## STRATEGIC DEVELOPMENT COMMITTEE

### Pre-application presentation

<b>Reference</b>	PF/19/00234
<b>Site</b>	Ensign House,
<b>Ward</b>	Canary Wharf
<b>Proposal</b>	Redevelopment of the site to provide a residential building up to 53-storey.
<b>Applicant</b>	Far East Consortium
<b>Architect</b>	Maccreeanor Lavington
<b>Agent</b>	DP9
<b>Case Officer</b>	Nelupa Malik
<b>Key dates</b>	Pre-application request submitted October 2019 Pre-app discussions began in October 2019 CADAP review in October 2020

*Proposed Scheme Presented before CADAP at 60-storeys.*

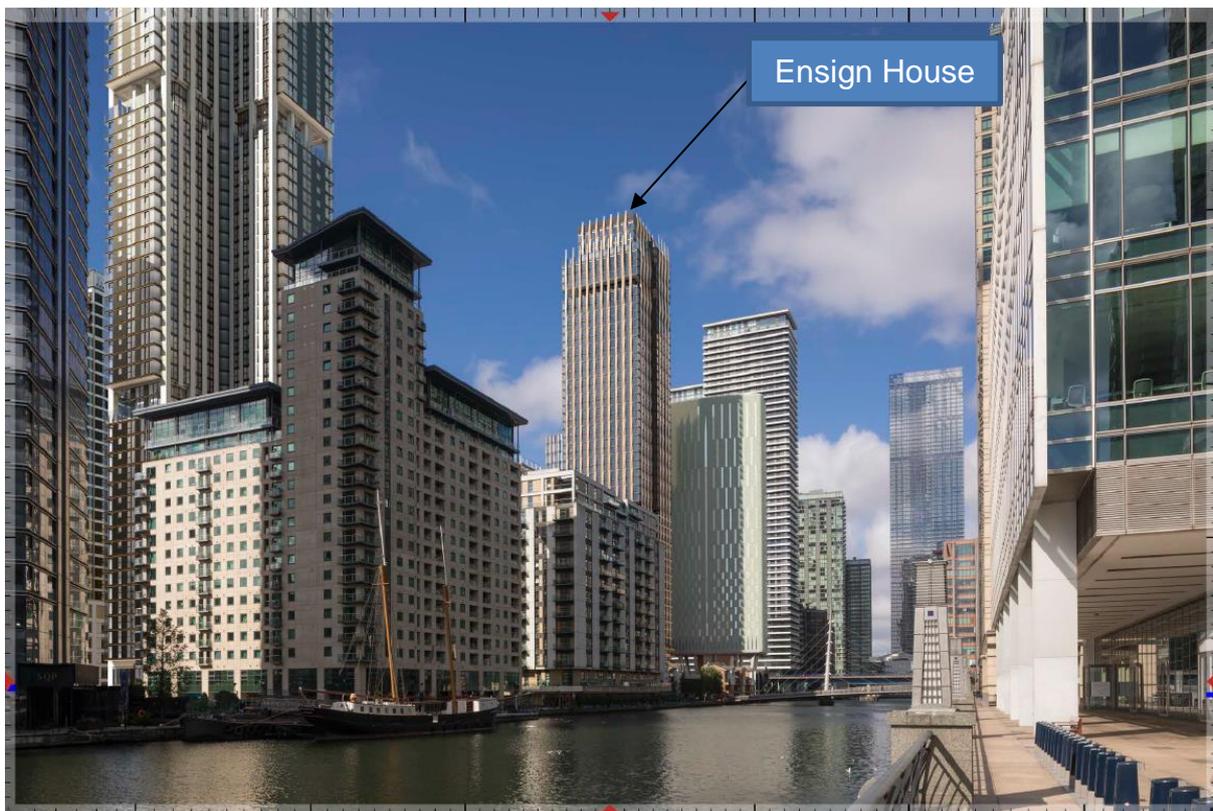
- Support the plinth, middle and top approach to design however highlighted that all the tall buildings shown in the developer's presentation were in fact commercial buildings and not residential. Residential buildings have different performance requirements.

- Panel members sought clarification on the sustainability aspirations for this building and suggested that overheating may be one of the biggest issues.

- Panel members admired the façade treatment however questioned its function and considered that it was important that the architectural expression did not appear simply 'stuck on'.

- Questions were raised as to whether there were any environmental benefits from the elevational treatment.
- Panel members were concerned that the scheme was referencing office buildings and that this resulted in a bulky footprint and a plan more suited to a commercial use than residential use.

- Concerns were raised about the quality of the flats with some floors having 12 units per floor and many of the flats were single aspect with no external amenity space.

- Concerns were raised that the scheme included 55% dual aspect units only.
- The absence of private amenity space for the private units were a concern and the approach to incorporate additional space internally and have large window openings instead was questioned.

- The proposal to have two lobbies; one for the private flats and one for the affordable was considered to create a 'poor door' effect.
- The panel members questioned the cycle parking provision which is proposed to be situated on two levels and the notion that these areas can be counted as amenity. Considered that this could work against the public face of the building.

- The panel supported the ambitions of the open space strategy, however noted that Marsh Wall has very poor air quality and raised concerns about the location of play space in relation to air quality.

- The panel expressed concerns about an imbalance between play and public space and the location of play space, much of which appears to be indoors.
- The panel noted that the play space for different age groups was entirely separated. Play space should be designed for the mix of different age groups.

- Concerns raised about how various development sites along Marsh Wall could be linked up.
- Support given to the covered walkway beneath the DLR and the opportunity of providing a colonnaded space was an exciting concept, however consideration needed to be given as to how this might work in practice.

- Overall, the panel felt the scheme offered an interesting architectural aesthetic, but before the height could be supported further work was required to resolve the issues arising from the plan as a result of the bulky footprint, amenity and open space issues. There is also a need for more work on sustainability.

*Proposed Tower at 53-storeys.*

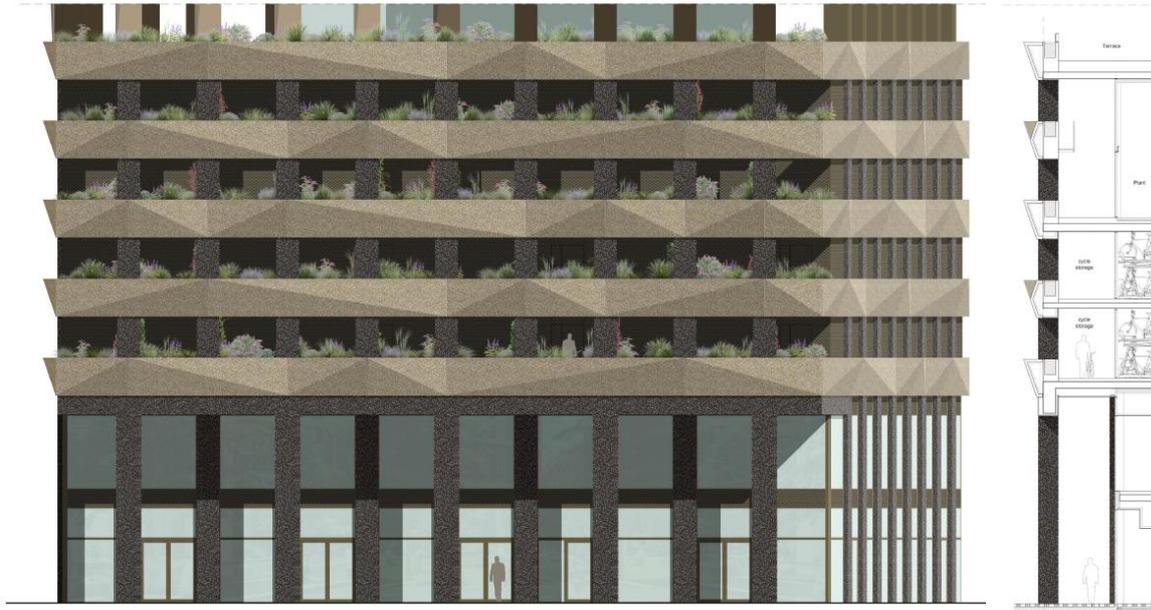
7.26 The scheme proposes a plinth and tower approach for the building. Concerns have been raised by Officers with regard to the height and massing of the proposal throughout the pre-application process. Officers have previously suggested that a scheme incorporating a height of 50-storeys would be more appropriate in this location and aligned with policy D.DH6 of the Local Plan, particularly in relation to the site's location on the edge of the Canary Wharf Tall Building Zone. However, Officers acknowledge that a 53-storey building that has a far greater level of articulation, detailing and design quality than that which is currently proposed could have the potential to appropriately respond to the tall building policy.

*Proposed Projecting Fins.*

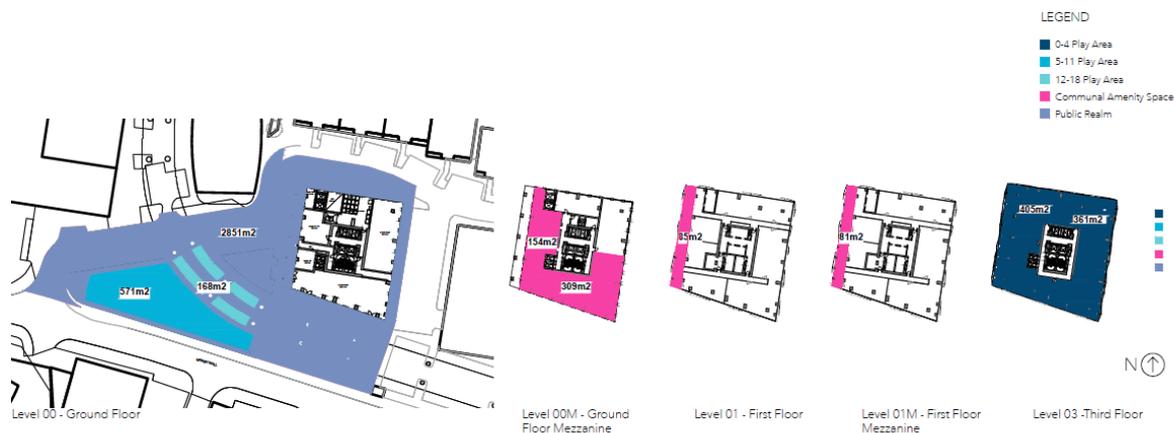
7.27 In terms of the proposed architectural treatment, the development proposes to express the building using copper/bronze coloured angular projecting fins arranged vertically. The materiality for the plinth is proposed to be polished concrete arranged horizontally and, in a colour/tone to reflect the material colour of the tower. In principle, Officers consider that this approach is interesting however further detailing is required with regards to its articulation to ensure that the quality of the development comes through successfully at an appropriate height.

## Comparison between 60-storey and 53-storey.

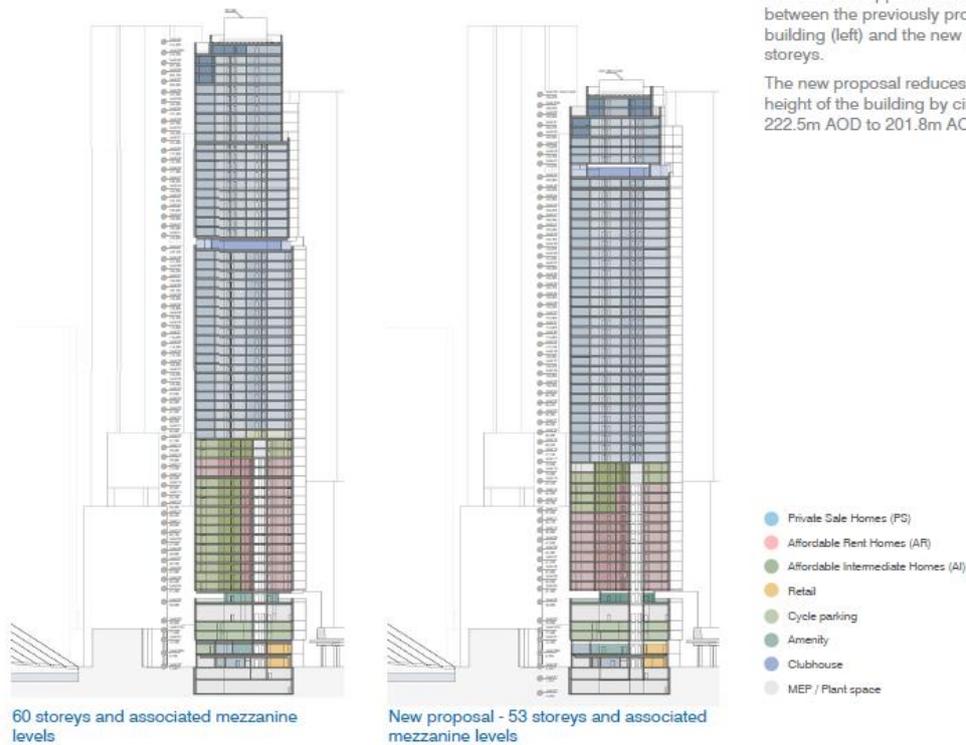
The sections opposite show a comparison between the previously proposed 60 storey building (left) and the new proposal at 53 storeys.

The new proposal reduces the overall height of the building by circa 21m from 222.5m AOD to 201.8m AOD
